TOWN OF COVENTRY, RI  
DEPARTMENT OF PLANNING & DEVELOPMENT

## STAFF REPORT

<b>Project Name:</b>	<b>Westwood Estates Reconfiguration Plan</b>
<b>Plan Type:</b>	Major Land Development with associated Zone Change
<b>Plan Review Phase:</b>	Master Plan
<b>Owners:</b>	Hometown America Communities, LLC
<b>Applicant:</b>	Same
<b>Address:</b>	1A Liena Rose Way
<b>Plat / Lot / Zone:</b>	<b>AP 32 Lot 32.1, AP 43 Lots 35 &amp; 35.1, AP 44 Lots 4, 5, &amp; 6 Zone PD Lot Size</b> 219.4 acres
<b>Existing Use:</b>	Mobile Home Park
<b>Proposed Use:</b>	Same with additional 46 units
<b>Description:</b>	The applicant, Hometown America Communities, LLC, is proposing to increase the number of mobile home sites within the property by 46 units through a combination of the creation of new infill sites along existing roads and three (3) new private roads within the property (Phase 1), and the relocation/reorientation of some existing mobile homes to allow for the installation of new mobile homes on adjacent sites (Phase 2). This proposal includes a corresponding Zone Change Application which will be subject to a recommendation by the Planning Commission and ultimately decided by the Town Council.

### T

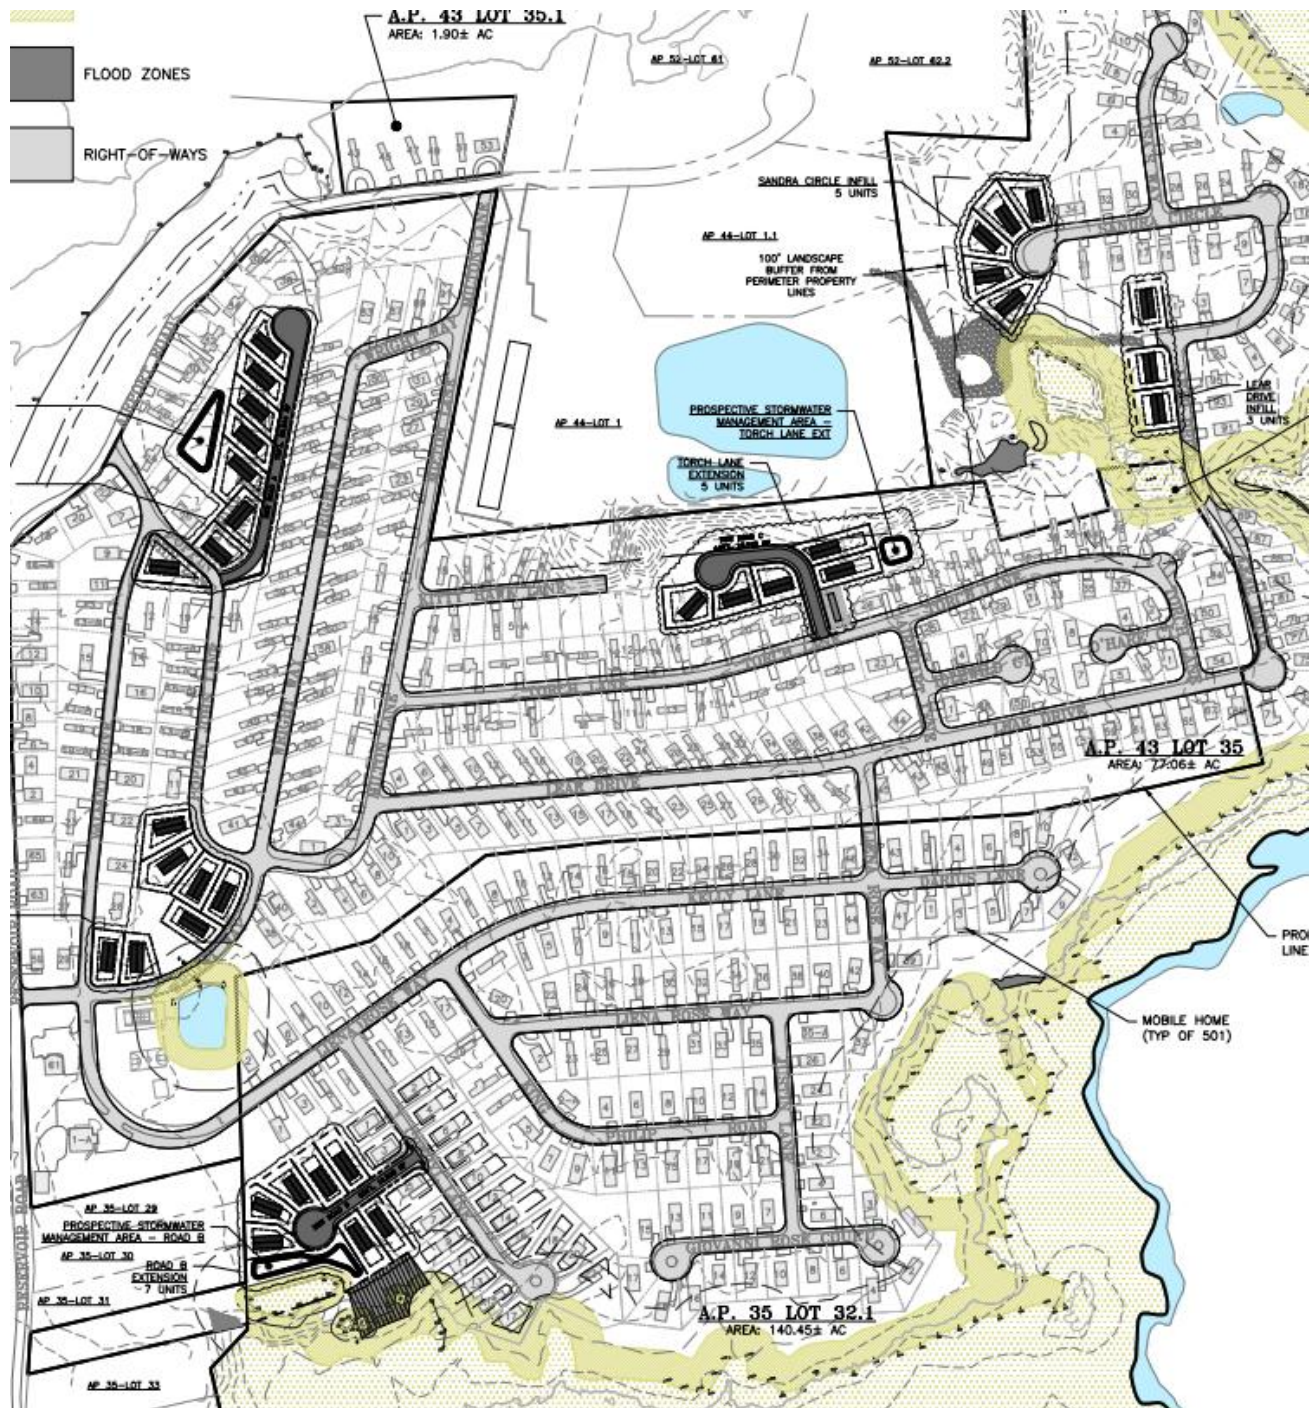
The project will create approximately 1,500 feet of roadway in three different places. Road “A” will come off of Poppin John Lane with 7 new units. Road “B” will be off of Cheryl Lane with 7 new units. Road “C” comes north off of Torch Lane with 5 additional units. Two things are of note with the proposed Road “C”. One, there will be a need to turn the current unit at 24 Torch Lane perpendicular to Torch Lane for the creation of the new road. Second, there is substantial encroachment from the north under the area that Road “C” would occupy. This would have to be resolved before construction could begin.

The applicant has provided areas on the proposed plans for areas of stormwater management. It is unclear if these proposed basins will meet the standards needed. Such calculations will be required at Preliminary Plan Stage. Previous expansions of the park have occurred with no stormwater infrastructure, most recently Cheryl Lane. This will have to be taken into consideration as there is now a chance to correct any missed stormwater infrastructure needs.

Additionally, the proposed plans showed units located on "Road B", off of Cheryl Lane, that are located within the 100' buffer as required in §255-1120B.(3). The applicant's engineer responded by saying they would redesign the roadway or remove the units so that resubmitted plans at Master Plan stage comply with this Code.

Planning Staff had brought up the idea of connecting the proposed "Road A" with a small stub that comes off of Airport Road as they are in proximity with each other. The applicant's engineer stated that they would look into that, but added that it may add a complication as Airport Road is a private roadway and

- Provide dimensions on site plan to demonstrate that all of the proposed sites meet the required 50' width at the setback line, specifically T1, T2, S1.

- Provide more information on the available parking/driveway locations for some of the proposed new units, specifically B6, B7, S4, S5, T1, T2.
- Provide more details on the physical method of moving the older units, including what would happen to units that get damaged.

- Provide clarification on how the application will maintain compliance with the required buffer on the new “Road B” (off Cheryl Lane). The proposed plans show little to no buffer where 100’ is required.

- Planning Staff requests that the applicant investigate whether the newly created “Road A” should connect to the stub that comes off of Airport Road that is in direct proximity in order to create this as a “through road”.
